# ALEXANDRIA RENEW ENTERPRISES

ITB No. 22-024

ADDENDUM NO. 1

**PRIMARY SETTLING TANK  
REHABILITATION**

**1 SITE PLAN**  
SCALE: 1" = 80'-0"

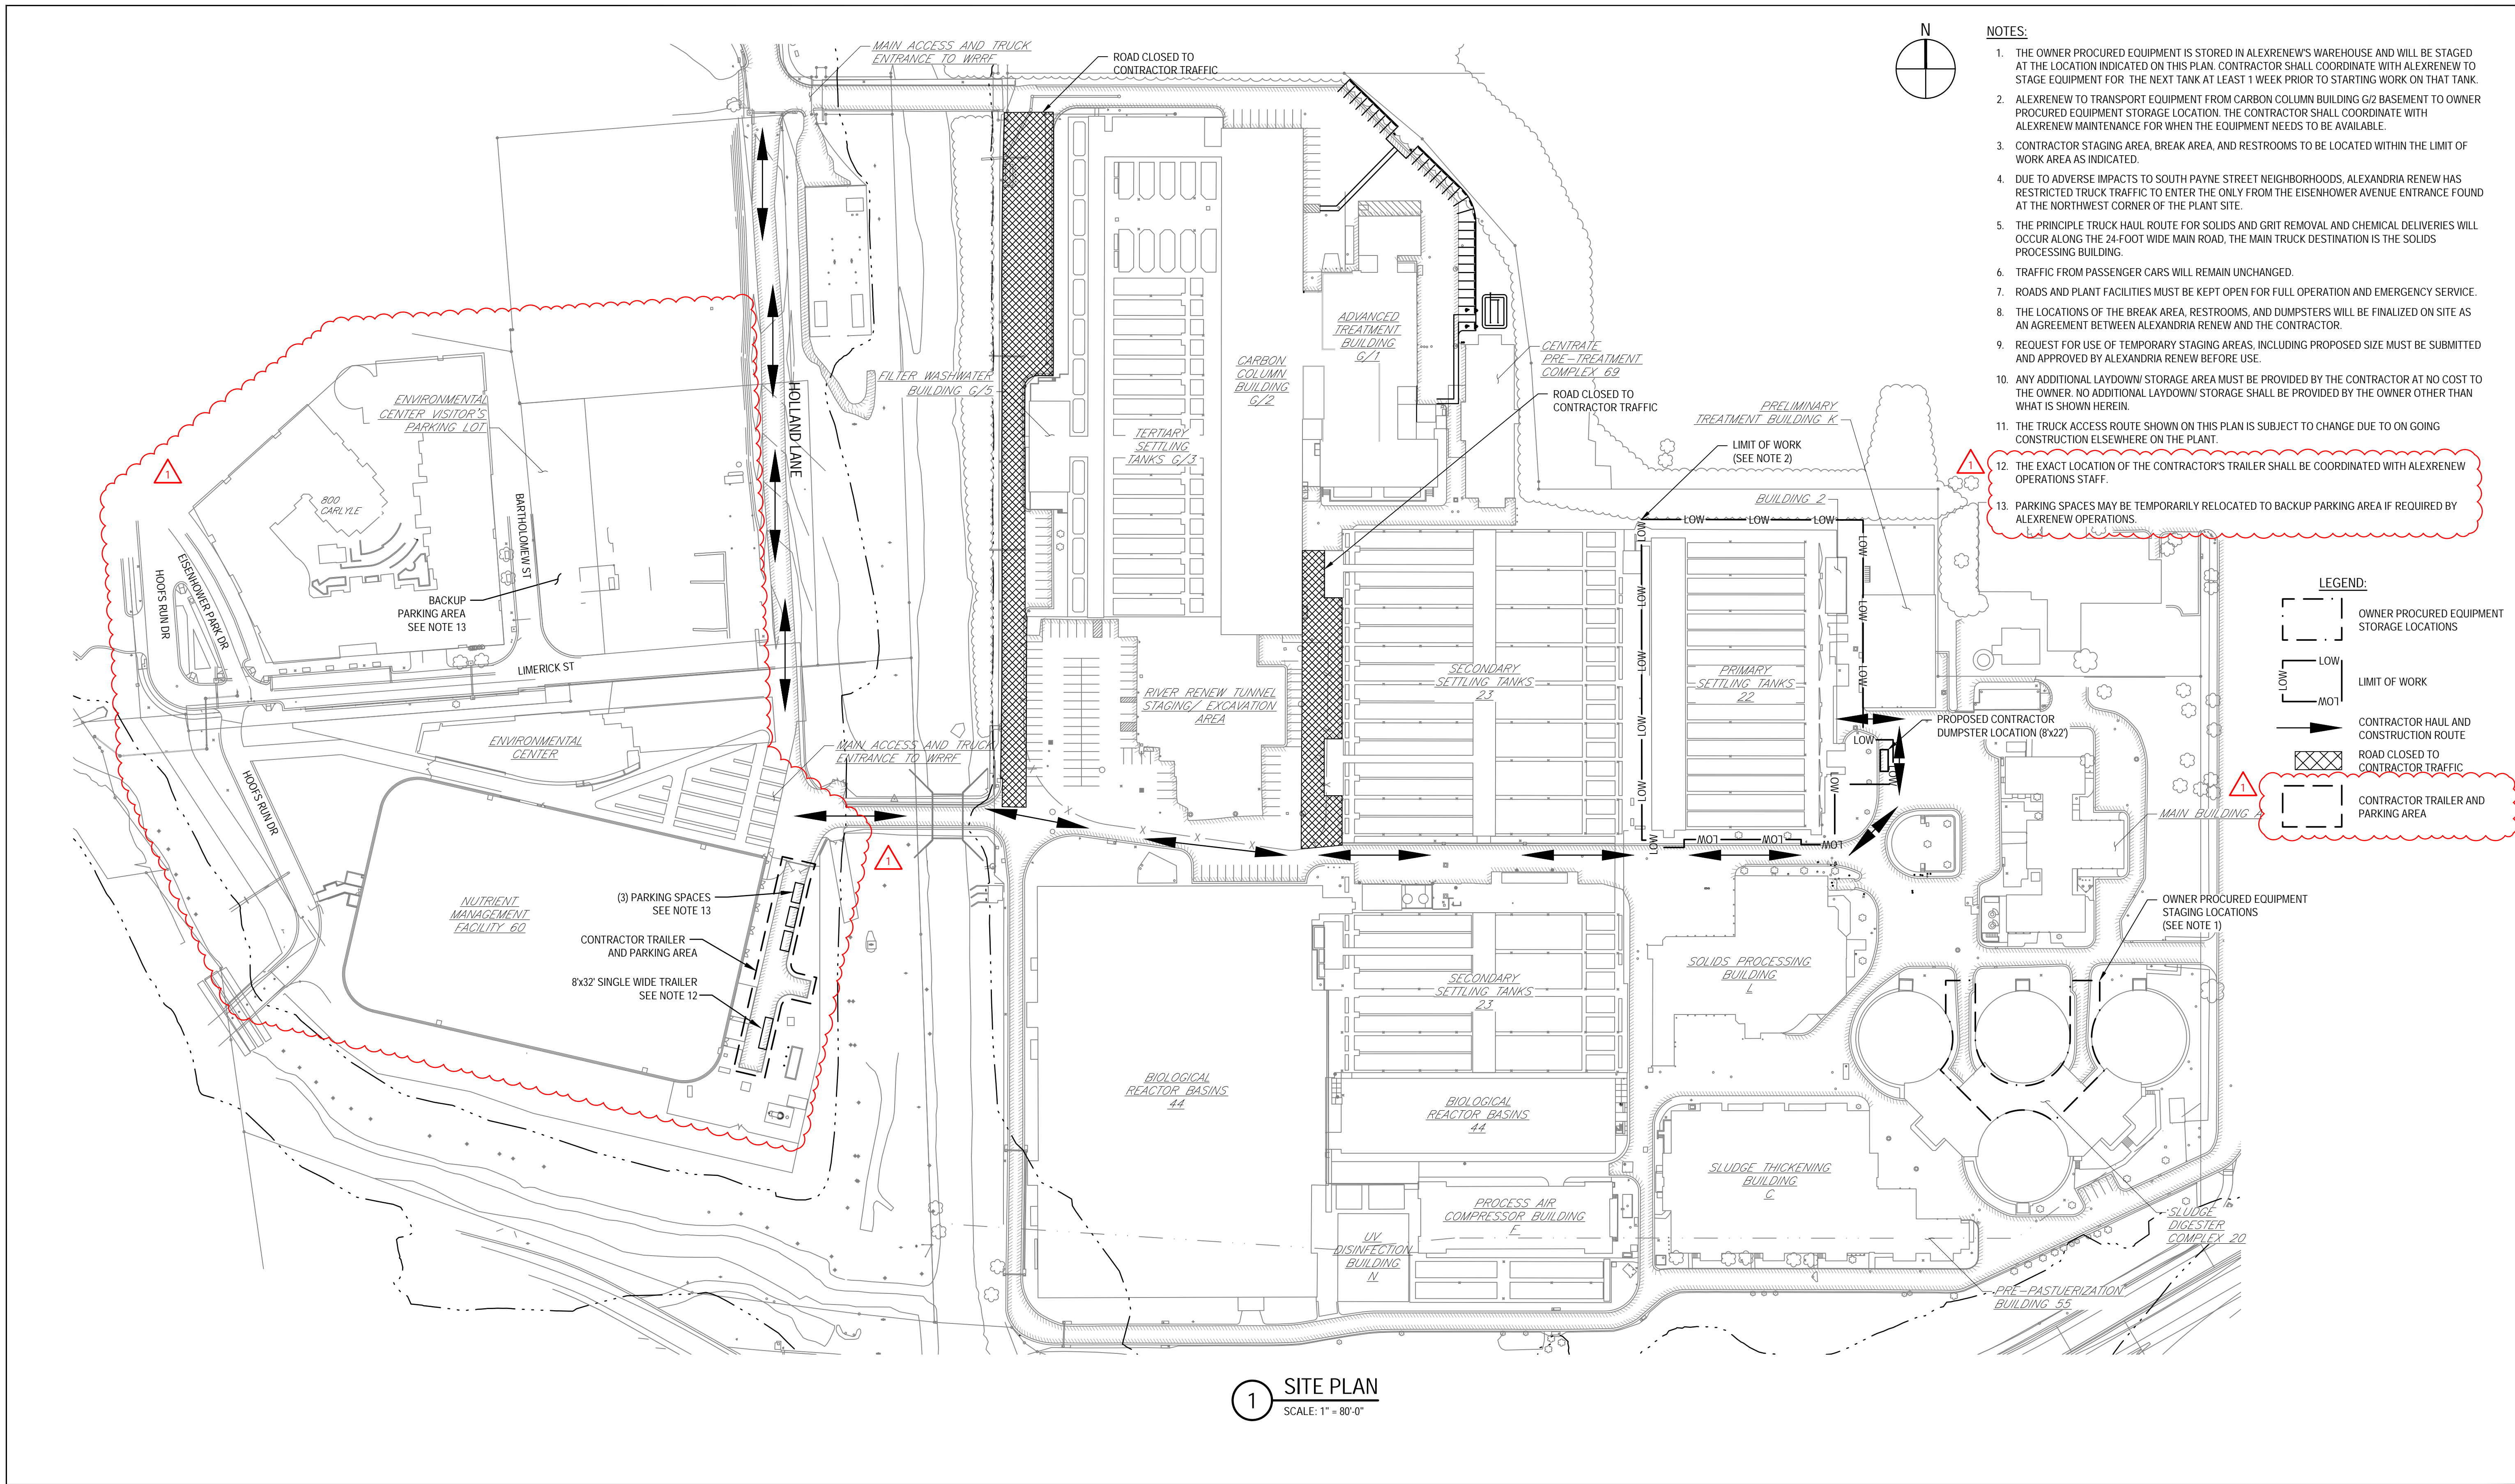
The attached drawing shall replace C001 sheet from the original contract drawings.

- NOTES:**
- THE OWNER PROCURED EQUIPMENT IS STORED IN ALEXRENEW'S WAREHOUSE AND WILL BE STAGED AT THE LOCATION INDICATED ON THIS PLAN. CONTRACTOR SHALL COORDINATE WITH ALEXRENEW TO STAGE EQUIPMENT FOR THE NEXT TANK AT LEAST 1 WEEK PRIOR TO STARTING WORK ON THAT TANK.

- ALEXRENEW TO TRANSPORT EQUIPMENT FROM CARBON COLUMN BUILDING G/2 BASEMENT TO OWNER PROCURED EQUIPMENT STORAGE LOCATION. THE CONTRACTOR SHALL COORDINATE WITH ALEXRENEW MAINTENANCE FOR WHEN THE EQUIPMENT NEEDS TO BE AVAILABLE.

- CONTRACTOR STAGING AREA, BREAK AREA, AND RESTROOMS TO BE LOCATED WITHIN THE LIMIT OF WORK AREA AS INDICATED.
  - DUE TO ADVERSE IMPACTS TO SOUTH PAYNE STREET NEIGHBORHOODS, ALEXANDRIA RENEW HAS RESTRICTED TRUCK TRAFFIC TO ENTER THE ONLY FROM THE EISENHOWER AVENUE ENTRANCE FOUND AT THE NORTHWEST CORNER OF THE PLANT SITE.
